Access Compliance Report Public Rights-of-Way (Curb Ramps)

Main Street: N/A Cross Street: ROSSMOOR_CENTER_WAY Location: S

ADA ID: RPRK211208115408 Ramp Type: Type 4 - Parallel Initial Pass/Fail: Fail Overall Compliance: No Severity Score: 2

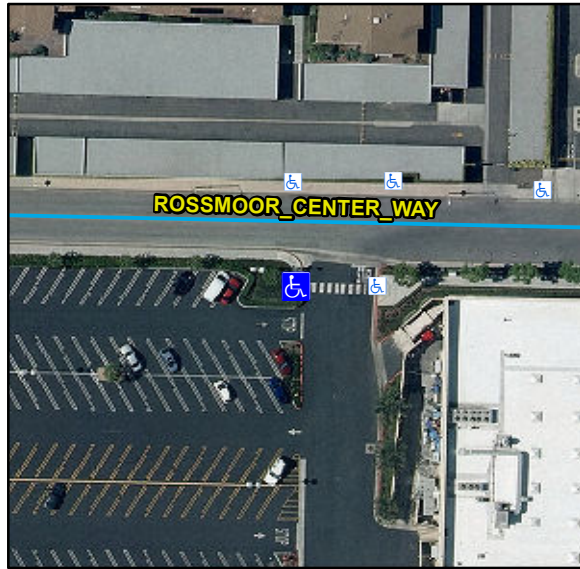
Compliance	Description	Data	Compliance	Description	Data
N/A	Ramp Length LT (in)	-9999	N/A	Ramp Length RT (in)	86
N/A	Ramp Width LT (in)	-9999	Yes	Ramp Width RT (in)	59
N/A	Ramp Run Slope LT (%)	-9999	Yes	Ramp Run Slope RT (%)	0.1
N/A	Ramp Cross Slope LT (%)	-9999	No	Ramp Cross Slope RT (%)	3.7
N/A	Landing Present	N/A	N/A	DWS Provided	N/A
N/A	Landing Length (in)	N/A	N/A	DWS Contrast	N/A
N/A	Landing Width (in)	N/A	N/A	DWS Length (in)	N/A
N/A	Landing Run Slope (%)	N/A	N/A	DWS Full Width	N/A
N/A	Landing Cross Slope (%)	N/A		DWS Offset Type	N/A
N/A	Landing Movement Obstructed?	N/A	N/A	DWS Offset Left (in)	N/A
	Landing Movement Type	N/A	N/A	DWS Offset Right (in)	N/A
N/A	Landing Shared	N/A			
N/A	Clear Space	N/A			
N/A	Clear Space To Crosswalk (in)	N/A			
N/A	Marked Crosswalk 1	Yes	N/A	Marked Crosswalk 2	N/A
	Crossing 1 Direction	E		Crossing 2 Direction	N/A
N/A	Marked Crosswalk 1 Width (in)	60		Marked Crosswalk 2 Width (in)	N/A

N/A	Ramp Inside Crosswalk 1	Yes	N/A	Ramp Inside Crosswalk 2	N/A
	Crossing 1 Slope (%)	5.4		Crossing 2 Slope (%)	N/A
	Crossing 1 Cross Slope (%)	0.1		Crossing 2 Cross Slope (%)	N/A
N/A	Gutter Ponding	N/A	Yes	Curb Slope	2
Yes	Gutter Lip Height (in)	0		Road Run Slope (%)	N/A
N/A	Gutter Run Slope (%)	N/A		Road Cross Slope (%)	N/A
N/A	Gutter Cross Slope (%)	N/A	Yes	Perpendicular Joint Present	Yes
Yes	Overall Surface Condition	Acceptable			
	Cross Gutter Present?	No		Spandrel Present?	No
	Replace Cross Gutter?	N/A		Replace Spandrel?	N/A

Remove & Replace Entire Ramp.

R304.5.3, STD 1115
